Docket No. 50-336  
B18294

**Millstone Nuclear Power Station, Unit No. 2**  
**Response to a Request For Additional Information Regarding Proposed Revision to**  
**Final Safety Analysis Report**  
**Fuel Centerline Melt Linear Heat Rate Limit (PLAR 2-00-2)**

**Response to a Request For Additional Information Regarding Proposed Revision  
to Final Safety Analysis Report  
Fuel Centerline Melt Linear Heat Rate Limit (PLAR 2-00-2)**

H2P FIGURE 14.1.5.2-10  
STEAM GENERATOR BREAK FLOW (HFP POST-SCRAM STEAM LINE OUTSIDE CONTAINMENT BREAK  
WITH LOSS OF OFFSITE POWER)

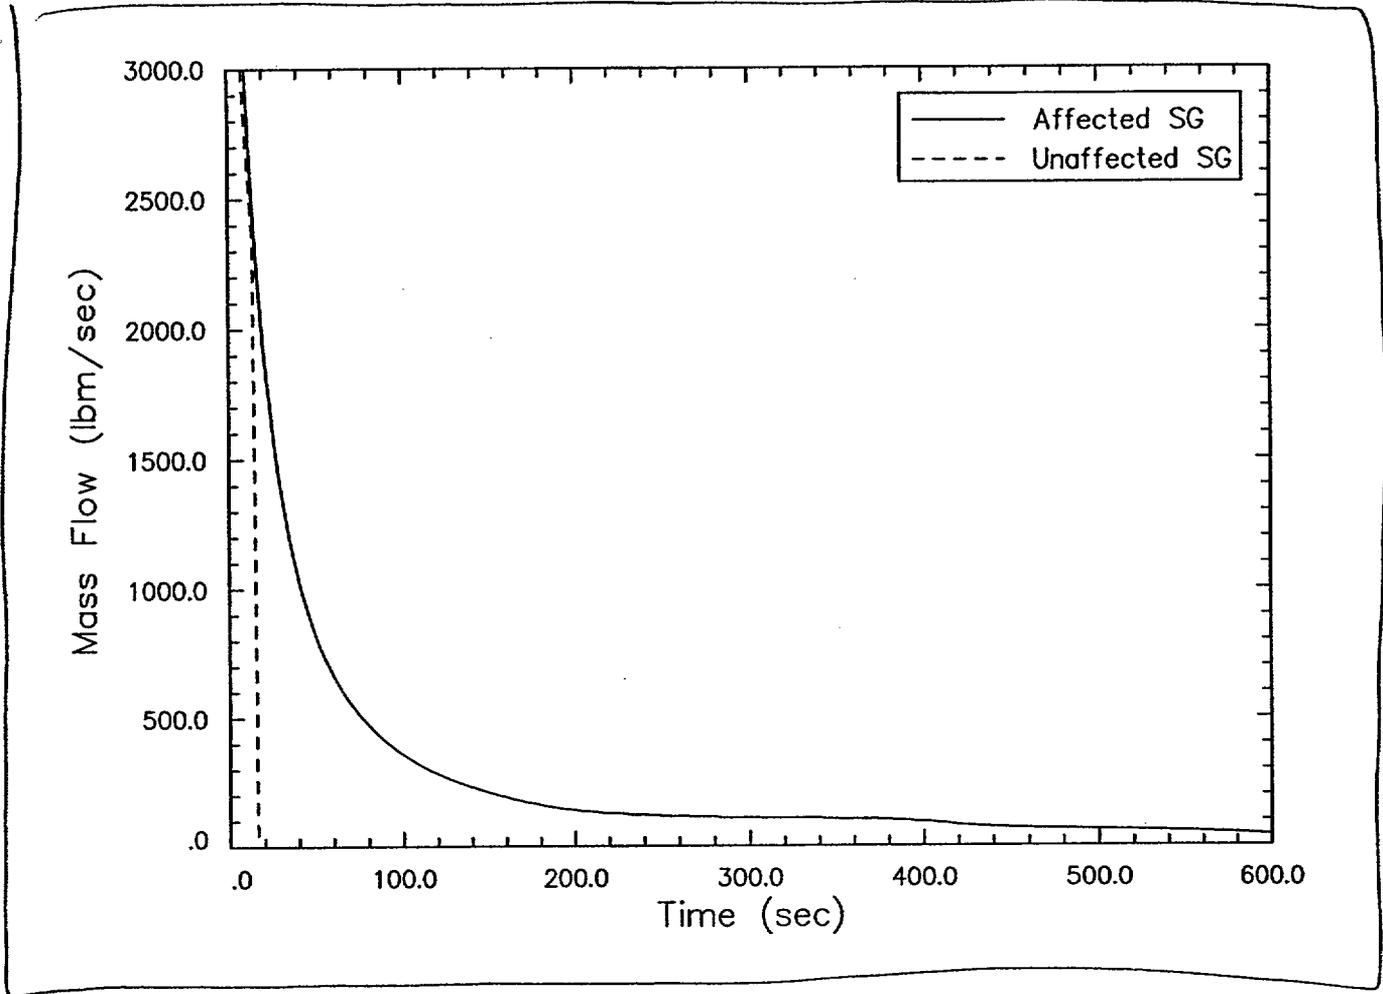
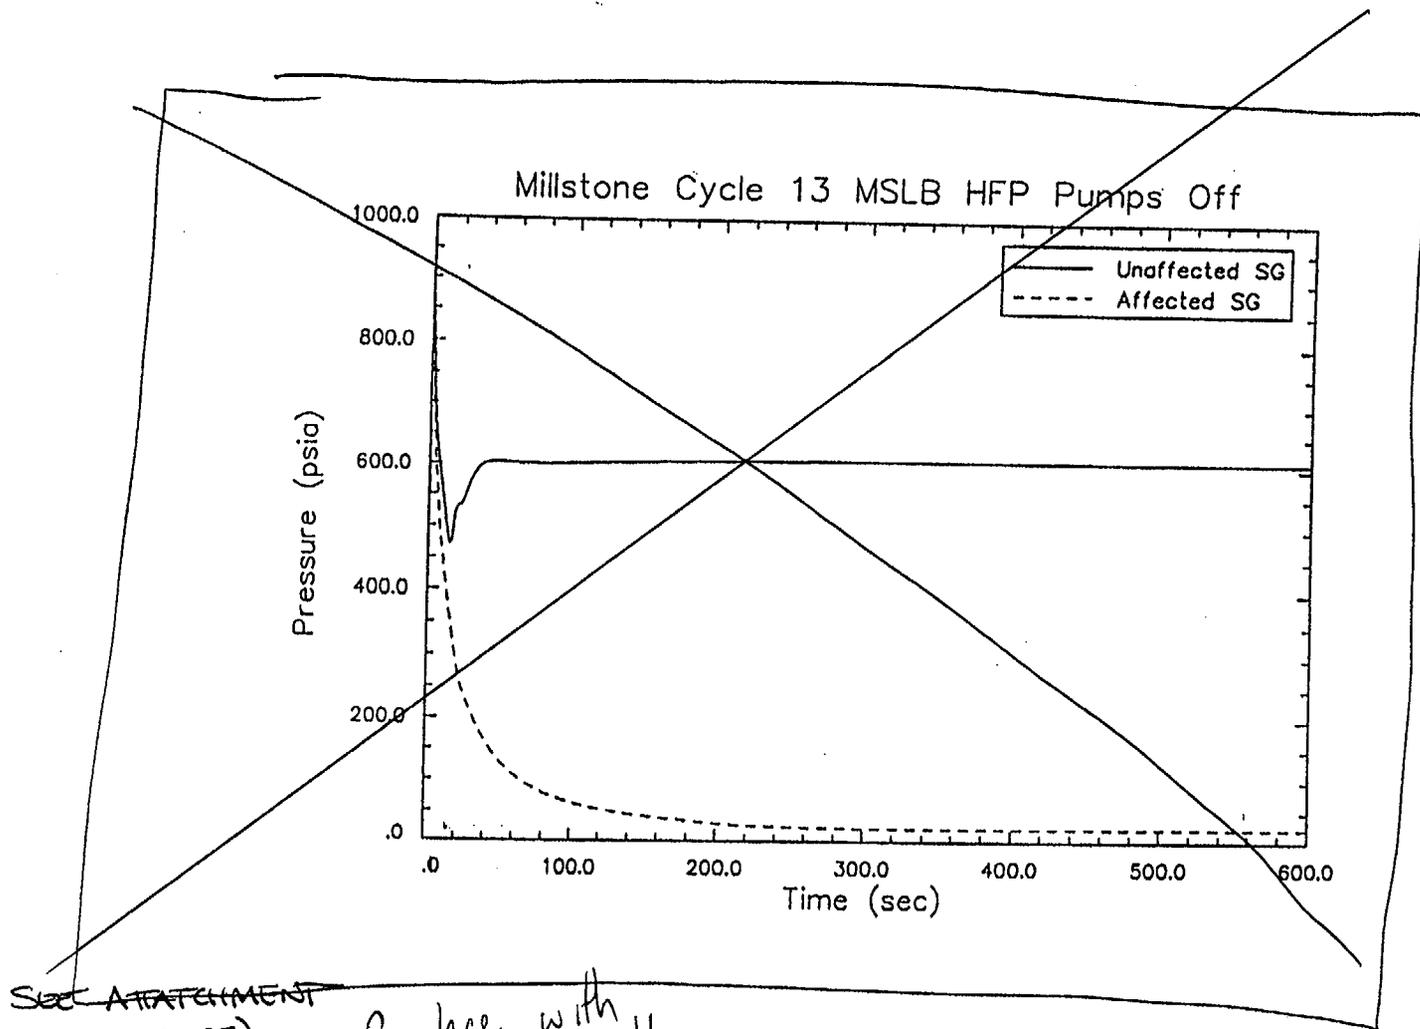
**Section 14.1.5.2.6.2 refers to Figs. 14.1.5.2-10 through 14.1.5.2-16 and Table 14.1.5.2-8 as representative of the HZP SLB event outside containment. However, these figures and table previously referred to the HFP event. Should they be revised accordingly?**

~~Figure 14.1.5.2-10 HZP Loss of Offsite Power  
(Break Flows)~~

The cited figures and table have been updated by an earlier FSAR change associated with the Cycle 14 reload design change. To provide more clarification, Attachment 2 includes a markup of the FSAR Section 14.1.5, including the associated tables and figures. This attachment includes the changes to FSAR Section 14.1.5 associated with the Cycle 14 SLB reanalyses, and the proposed changes associated with the change to a cycle specific linear heat rate limit. The changes associated with the Cycle 14 SLB reanalyses are identified by FSAR Change Numbers 00-MP2-23 and 00-MP2-39 in the attachment. The proposed changes associated with the cycle specific linear heat rate limit are identified by FSAR Change Number 00-MP2-38 in the attachment.

~~SEE ATTACHMENT~~  
(NEXT PAGE)

Replace with  
Figure 11

FIGURE 14.1.5.2-11 <sup>H2P</sup>  
STEAM GENERATORS' SECONDARY PRESSURES (HFP POST-SCRAM STEAM LINE OUTSIDE CONTAINMENT  
BREAK WITH LOSS OF OFFSITE POWER)

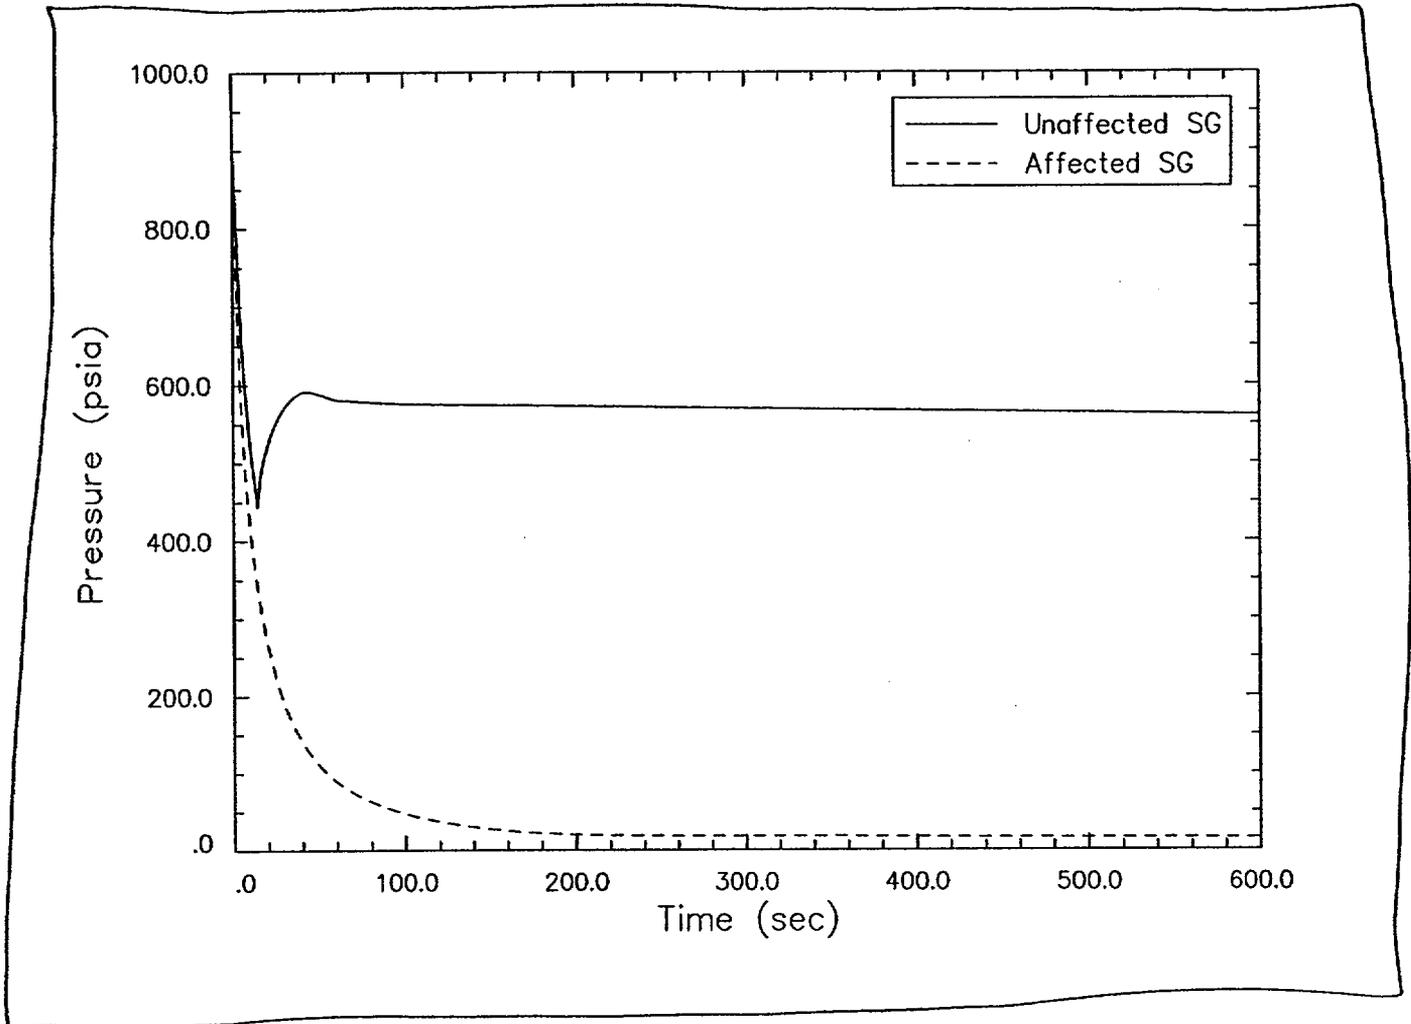
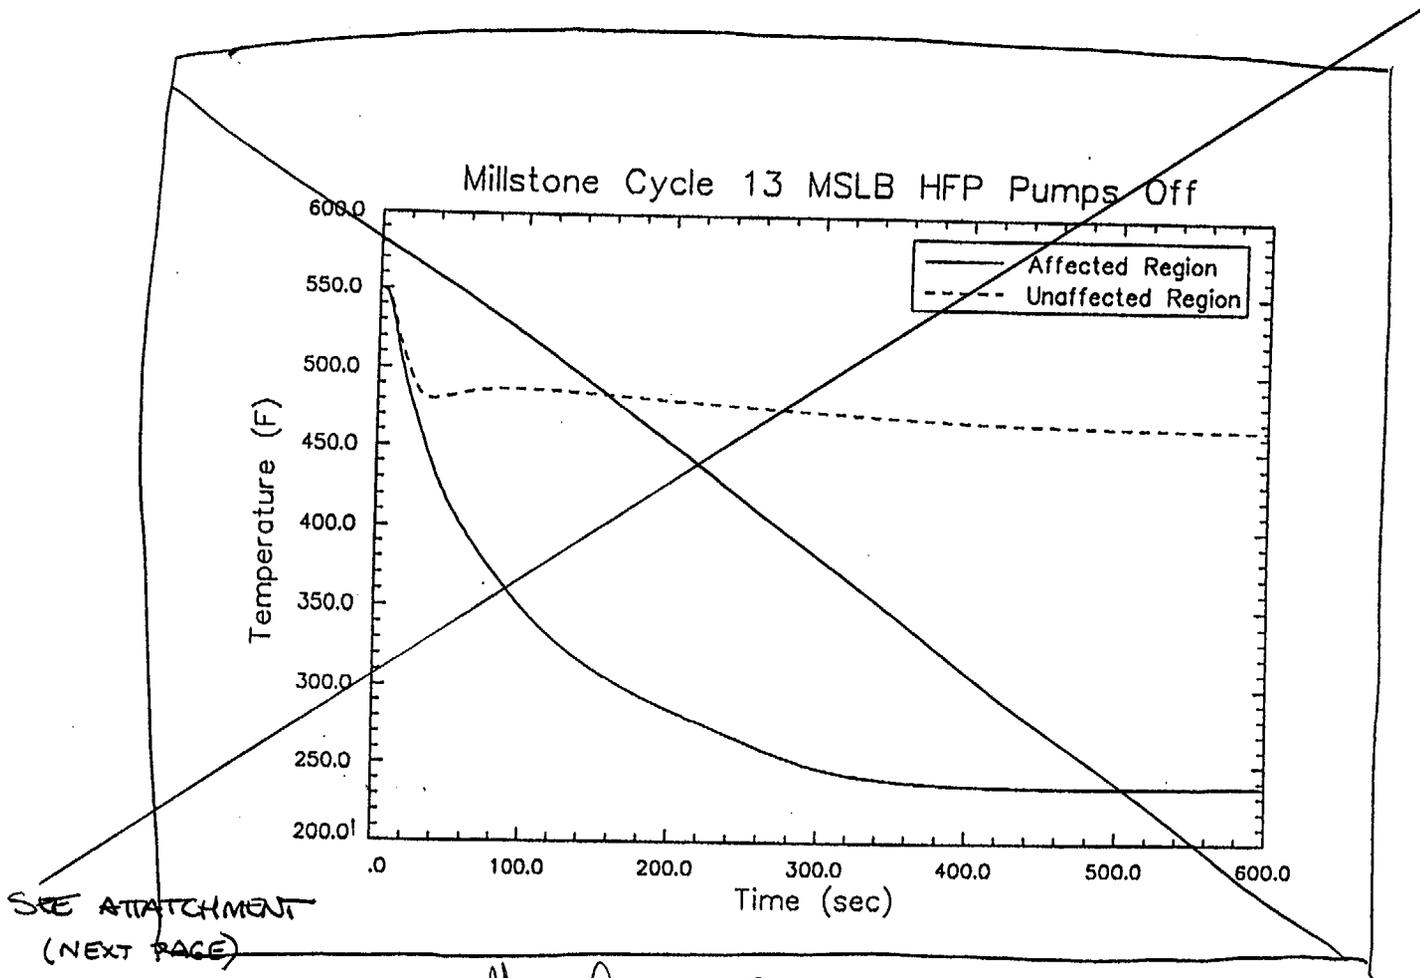
~~Figure 14.1.5.2-11 HZP Loss of Offsite Power  
(Steam Generators' Secondary Pressures)~~

SEE ATTACHMENT  
(NEXT PAGE)

Replace with figure 12

H2P FIGURE 14.1.5.2-12  
CORE INLET TEMPERATURES (HFP) POST-SCRAM STEAM LINE OUTSIDE CONTAINMENT BREAK  
WITH LOSS OF OFFSITE POWER)

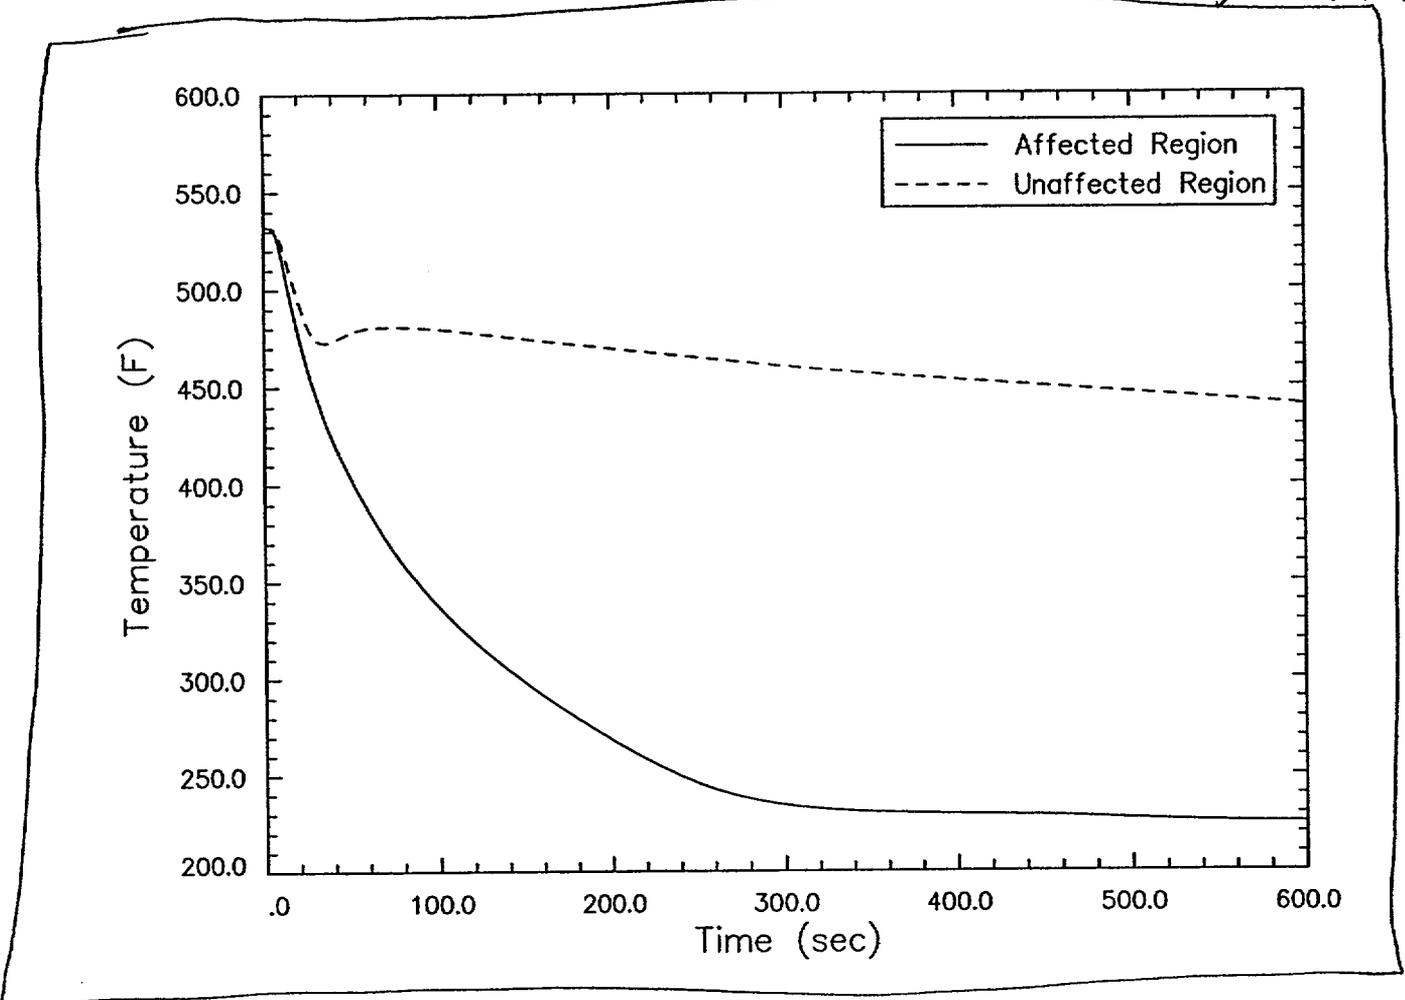
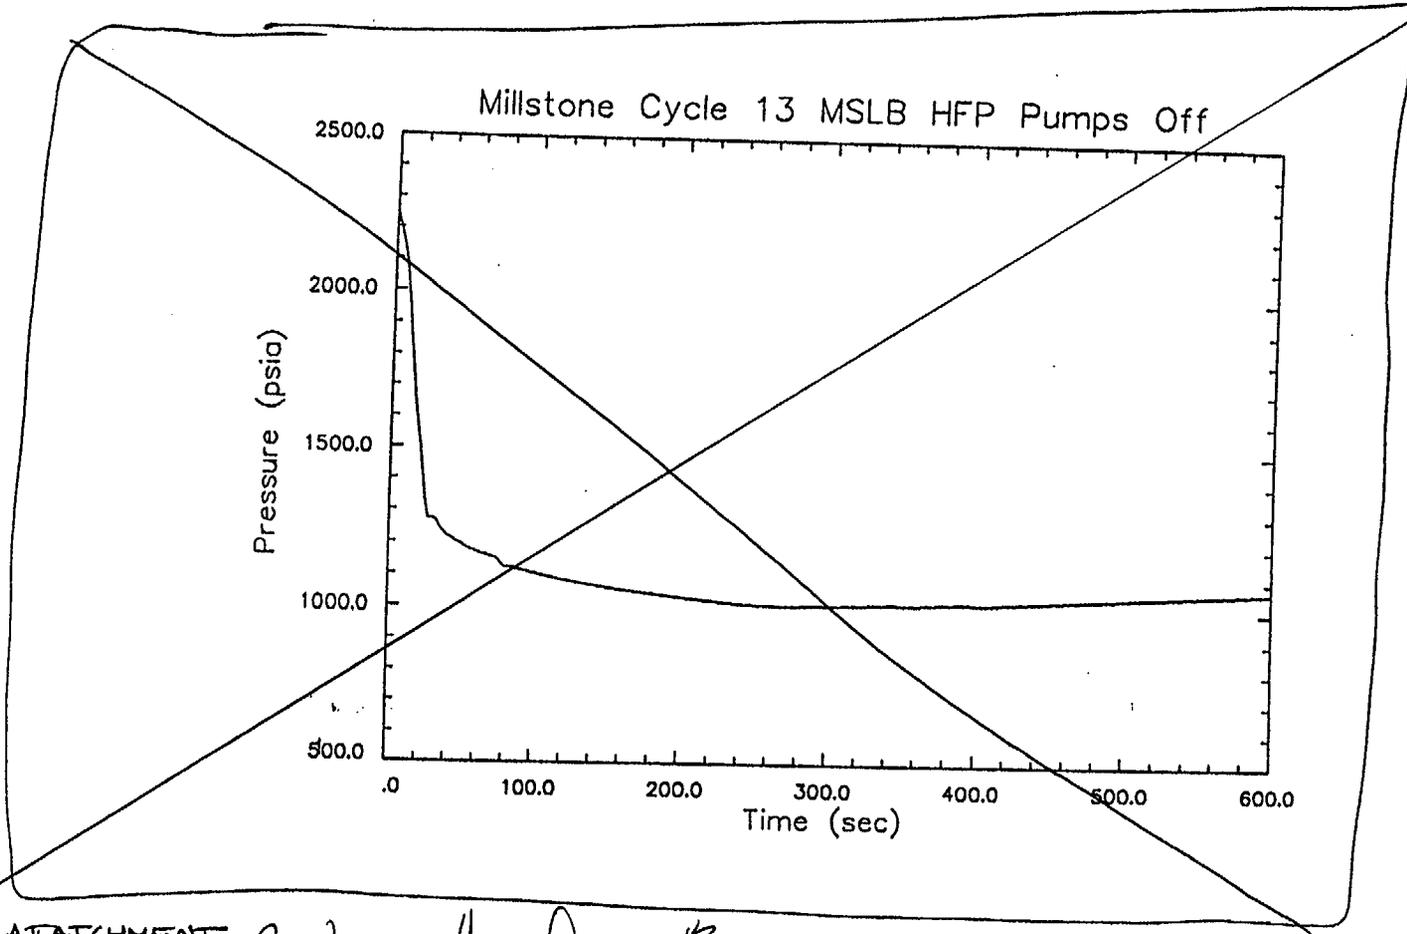
~~Figure 14.1.5.2-12 HZP Loss of Offsite Power  
(Core Inlet Temperatures)~~

SEE ATTACHMENT  
(NEXT PAGE)

*Replace with Figure 13*
